**Re.: Report of the Independent Peer Review Panel for the Groundwater Monitoring, Management, and Mitigation Plan (GMMMP) for the Cadiz Project**

REPORT OF THE INDEPENDENT PEER REVIEW PANEL  
FOR THE GROUNDWATER MANAGEMENT,  
MONITORING, AND MITIGATION PLAN (GMMMP)  
FOR THE CADIZ VALLEY GROUNDWATER  
CONSERVATION, RECOVERY AND STORAGE PROJECT  
San Bernardino County, California

**Figure 9: Lag in drawdown response related to the cessation of pumping at the Cadiz Project**

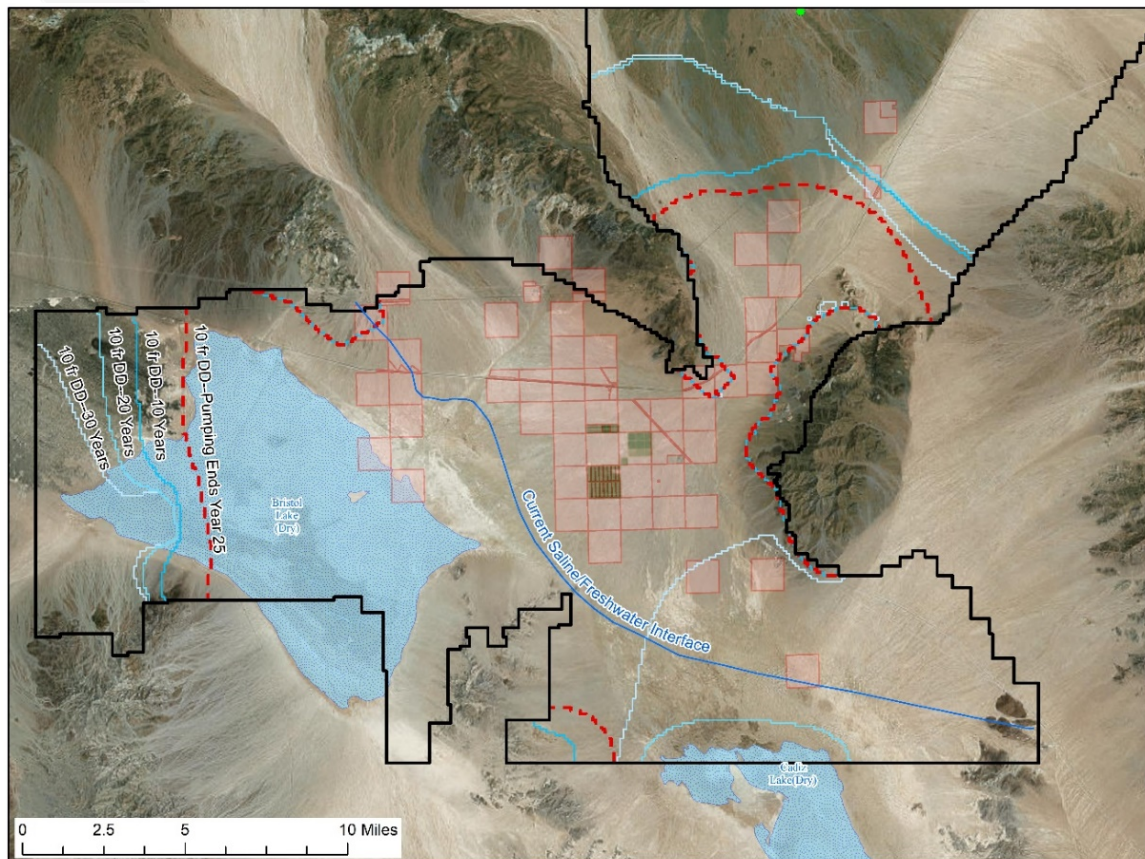
An illustration of the drawdown response in this model simulation is shown on **Figure 9**. The red dashed line (contour) indicates the location of 10 feet of drawdown after 25 years of pumping at the Cadiz Project. At the beginning of the 26<sup>th</sup> year when pumping stops, the blue lines illustrate the expansion of the 10-foot drawdown contour outward for the next 10, 20 and 30 years after pumping stops. That is, drawdown exceeds 10 feet for many years after that mitigation has been implemented – the cessation of pumping. Under such circumstances, an Undesirable Result may occur at a Critical Resource even many years after the implementation of the mitigation action (i.e., the cessation of pumping).

This model simulation is presented for illustrative purposes and further model simulations could be run to assess groundwater level responses to the mitigation actions proposed in the GMMMP once the Cadiz Project becomes operational, new data are collected, and the groundwater model is updated. In particular, simulations should examine whether a trigger threshold should be adjusted to account for the time lag between an action and the response at a monitoring point being used to assess Undesirable Results. Trigger thresholds for drawdown tied to several defined periods of time for a particular Critical Resource should also be evaluated. In addition, alternative mitigation actions that do not have time lag response issues (e.g., recharging the aquifer proximate to the Critical Resource) should be evaluated.

A groundwater level drawdown threshold (80 feet) is proposed in the GMMMP for a distance of two miles from the center of the Cadiz Project well-field. This threshold is intended to provide a management “floor” below which mitigation actions would be triggered. Such a floor was selected as it lessens the need for resource-specific mitigation actions at individual Critical Resources, as it is believed to provide a proactive Corrective Measure that would prevent significant impact.

It should be noted that the drawdown threshold two miles from the center of the Cadiz Project well-field may trigger mitigation when none is actually required. For example, if the 80-foot threshold is triggered, but unacceptable groundwater level declines are not observed closer to the springs (e.g., at monitoring well 6N15E1) or brine resources, no mitigation should be required. Conversely, if the 80-foot drawdown threshold is not triggered, but groundwater level declines observed closer to Critical Resources suggest an Undesirable Result could occur, then mitigation may be required. For these reasons, adequate monitoring is needed as close as reasonably possible to the Critical Resources. If monitoring closer to the Critical Resources indicates that an Undesirable Result could occur, then mitigation can be implemented.

**Figure 10: Excerpt of Monitoring Features from Figure 5-1 of the GMMMP (ESA, 2012b)**

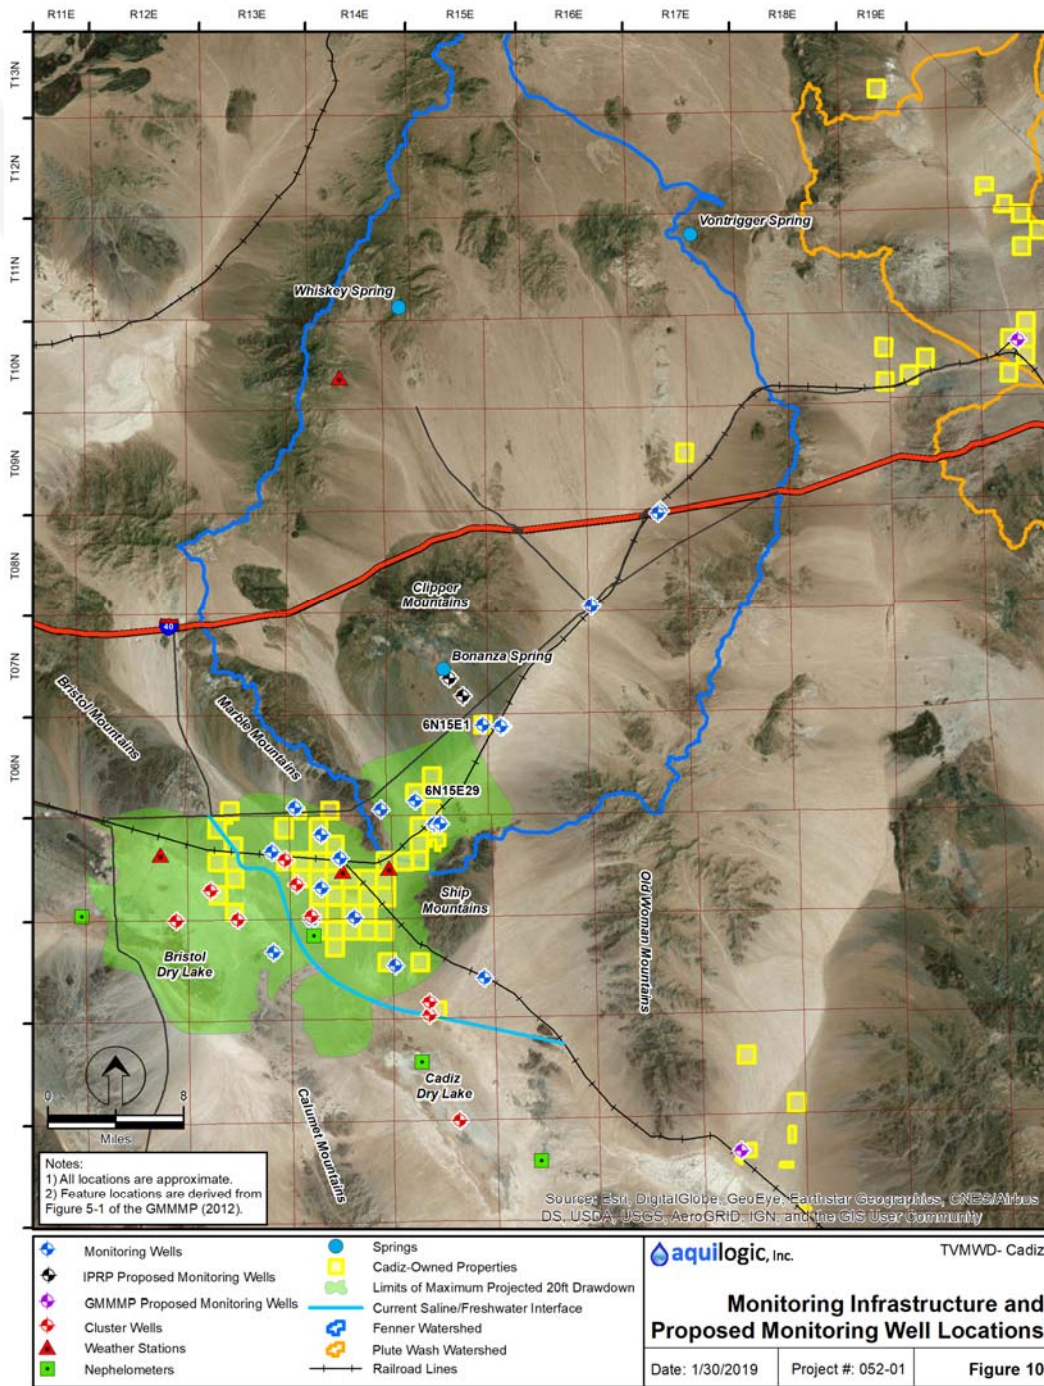
The perimeter of the green area on **Figure 10** indicates the maximum extent of 20 feet of drawdown in the alluvial aquifer resulting from the proposed pumping at the Cadiz Project, with the numerical groundwater model calibrated to recharge of 32,000 AFY. The maximum extent of 20 feet of drawdown extends to the contact between the alluvium and the bedrock of the Clipper Mountains south of Bonanza Spring. It also extends beyond the mineral strip-mining operations at Bristol Dry Lake.

In the GMMMP (ESA, 2012b), it is proposed that groundwater conditions be monitored at wells 6N15E1 and 6N15E29 (see **Figure 10**) to observe the propagation of the cone of depression outward from the proposed pumping at the Cadiz Project toward Bonanza Spring. These wells would serve as sentry wells – providing an early indication of potential Undesirable Results at Bonanza Spring, assuming there is a direct hydraulic connection between the spring and the alluvial aquifer.

In the current GMMMP (ESA, 2012b, see Figure 5-1, p. 64), groundwater levels and water quality will be monitored in the Fenner Valley at 14 existing monitoring wells plus two proposed monitoring wells (Danby-1 located between Chubbuck and Rice; and Piute-1 located east of Goffs). It is proposed in Appendix B of the GMMMP (ESA, 2012b, p. 122) that groundwater level measurements be taken at various frequencies depending on well and operating period. In the

**Figure 11: Drawdown Beneath Bristol Lake Under Three Recharge Scenarios (GSSI, 2011)**

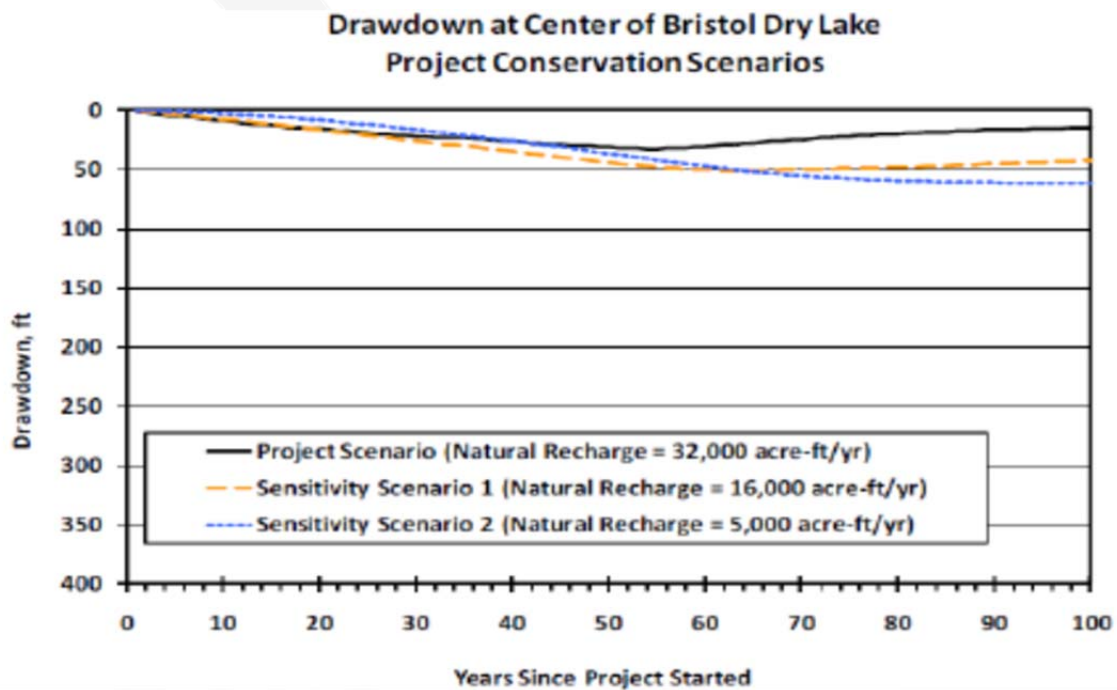
The hydrograph below in **Figure 11** (GSSI, 2011) shows the projected drawdown of groundwater levels beneath the Bristol Dry Lake during the proposed pumping at the Cadiz Project. The hydrograph was produced from numerical groundwater modeling performed by GSSI (2011). It shows that, depending on the recharge amount used in the modeling, between 30 and 65 feet of drawdown will occur beneath Bristol Dry Lake. In general, the trenches used to expose saline groundwater to evaporation and precipitate salts for mineral strip-mining operations at Bristol Dry Lake are about 12 feet deep, and the two existing strip-mining operators utilize approximately 750 AFY of brine water. Therefore, once groundwater levels beneath Bristol Dry Lake decline below 12 feet bgs, the trenches will be dry, curtailing some strip-mining operations and processes. However, it is understood that the strip-mining operations already pump groundwater from existing wells into the trenches. In addition, under natural climatic conditions, groundwater levels beneath the dry lakes decline at times, and the trenches are then dry.

Viewed strictly from the standpoint of whether the project is causing a physical change in the environment, and if there were a need for a “physical solution” if the groundwater level predictions from the modeling come to pass, it is likely that Corrective Measures will need to be implemented as outlined in the GMMMP (ESA, 2012b) to mitigate impacts on the strip-mining businesses. These Corrective Measures include operational modifications and/or negotiation of a compensation or mitigation agreement with mineral strip-mining operator(s). Such an agreement would require that Cadiz bear all of the costs of drilling wells to pump the brine, as the strip-mining operators do presently in some locations, rather than rely on the high groundwater table to fill evaporation/precipitation trenches. For example, brine extraction wells deeper than 70 feet bgs could be installed to maintain mineral strip-mining at Bristol Dry Lake.

**Figure 12: Simulated Et for Three Recharge Scenarios** (lower chart is an expansion of the bottom 1,500 AFY of the upper chart).

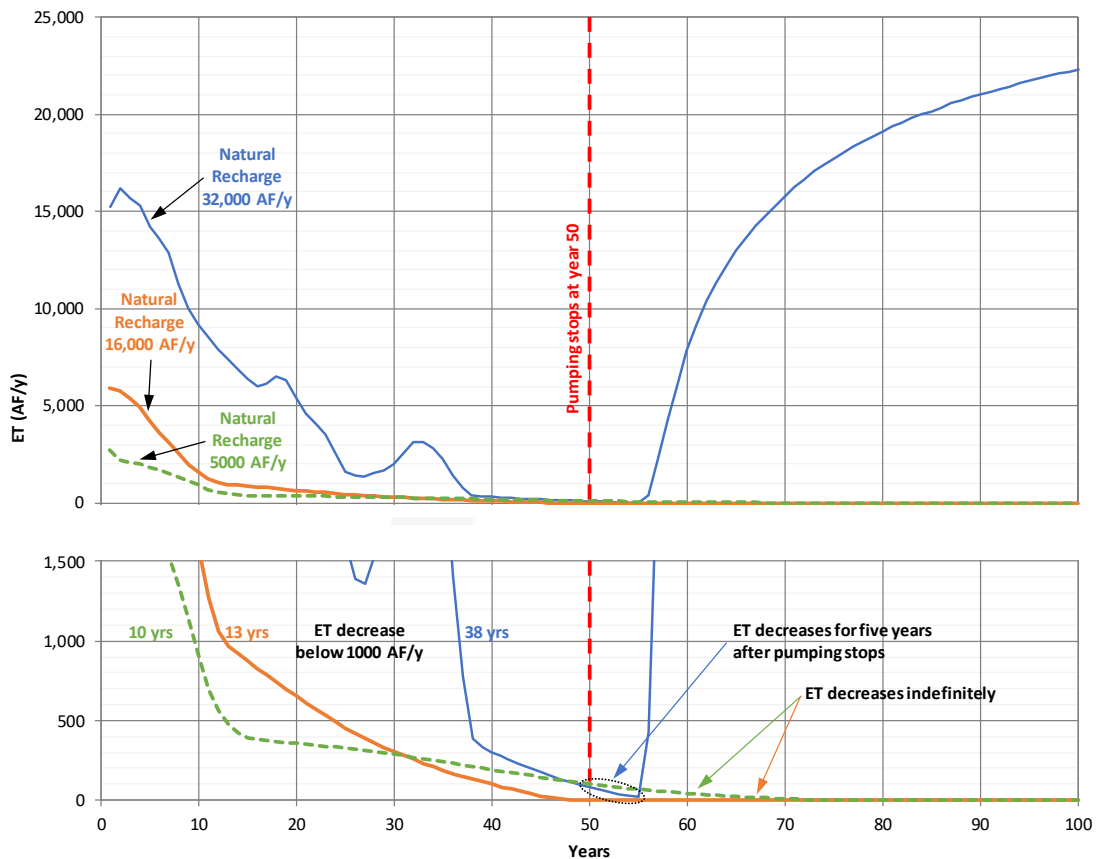
GSSI (2011, Tables 2, 3 and 4) ran three model simulations to provide water budget tables that include total Et for three project scenarios with different recharge rates (Project scenario: 32,000 AFY, Sensitivity 1: 16,000 AFY and Sensitivity 2: 5,000 AFY - GMMMP, p. 41 - 42). **Figure**

Two important observations are apparent in **Figure 12**:

Figure 13: Potential Geophysical Survey Areas

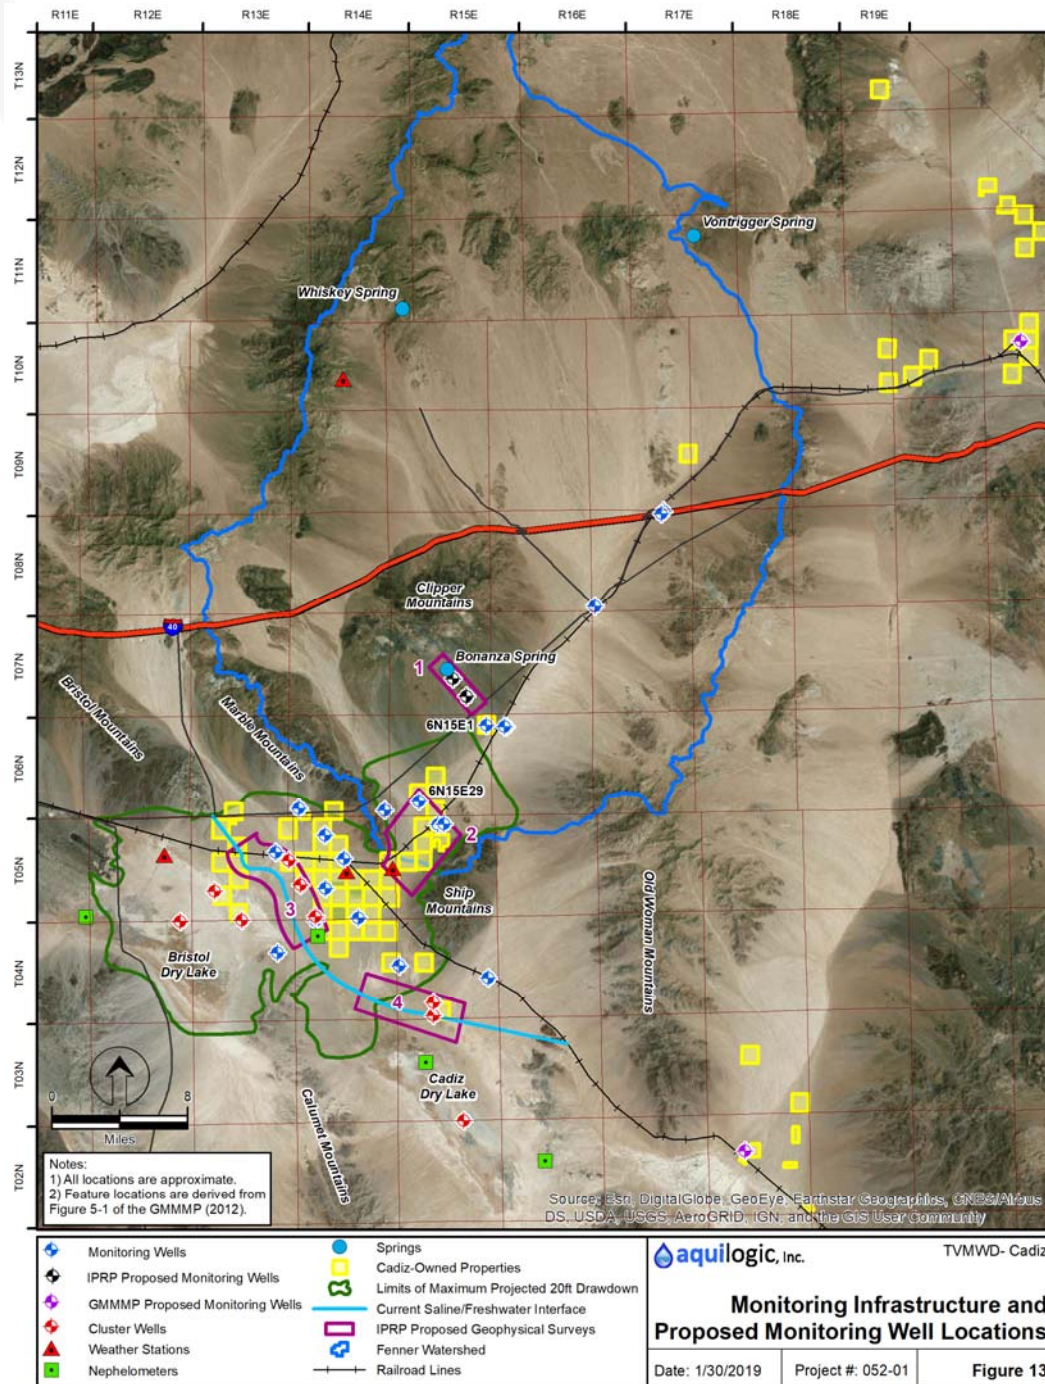
It is recommended that, within one year of the commencement of the proposed pumping at the Cadiz Project, geophysical surveys be completed in two areas to assist in assessing geologic conditions (areas 1 and 2 on **Figure 13**):

To provide additional information on hydrogeologic conditions between Bonanza Spring and the alluvial aquifer in the Fenner Valley below, it is recommended that the following additional monitoring wells be installed (see **Figure 13**):

Given the above, it is recommended that the location of the interface be mapped spatially and at depth using geophysical techniques (areas 3 and 4 on **Figure 13**) prior to the commencement of pumping at the Cadiz Project. Given the relative homogeneity of the alluvial deposits and known groundwater depth, EM techniques will be effective at mapping the mineralization of groundwater (i.e., TDS content). Different EM tools can be used to spatially map groundwater mineralization at various depths. ERT can also be used to map vertical profiles of groundwater mineralization along cross-section lines. The outputs from the spatial EM mapping and ERT can be combined to create a three-dimensional visualization of the saline-fresh water interface. The results of this geophysical mapping can be used to locate the proposed cluster wells, and select the screened depths at each cluster. It is further recommended that the geophysical mapping be repeated every five years after the proposed pumping at the Cadiz Project is initiated. This will allow the migration of the saline-fresh water interface to be mapped in three-dimensions over time. An understanding of the migration of the saline-fresh water interface will allow any potential mitigation actions to be optimized (e.g., recharge of fresh water in areas and depths of preferential migration).
